**IN THE DRAWINGS**

### REMARKS

FIG. 1A (RELATED ART)

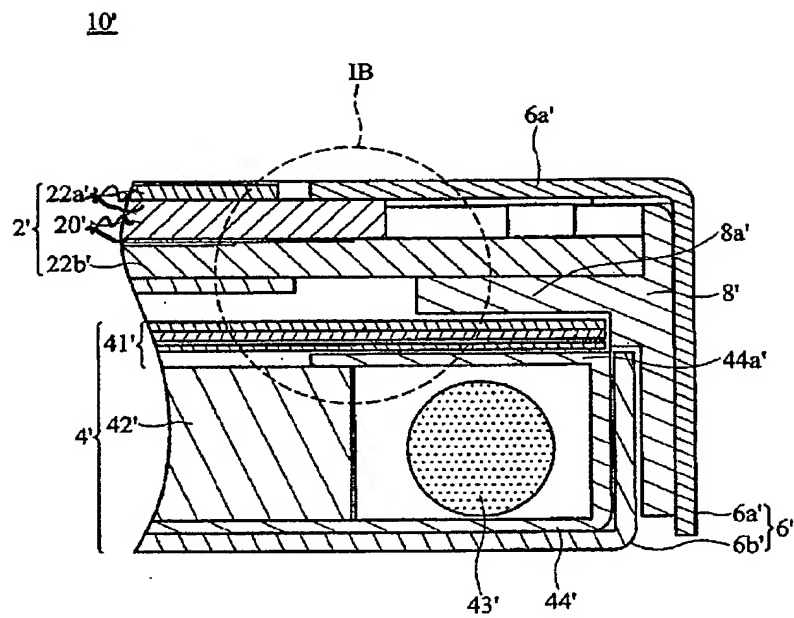
Please replace Figs. 1A, 2A, 2B, 3A and 3B with corrected drawings in the attached sheets. In these drawing sheets, minor changes have been made to lead line and reference designators, as shown in the annotated drawing sheets.

The drawings are corrected according to the description of the specification. Specifically, minor changes are made to lead lines and reference designators of the drawings, as illustrated in the accompanying annotated and replacement drawing sheets.
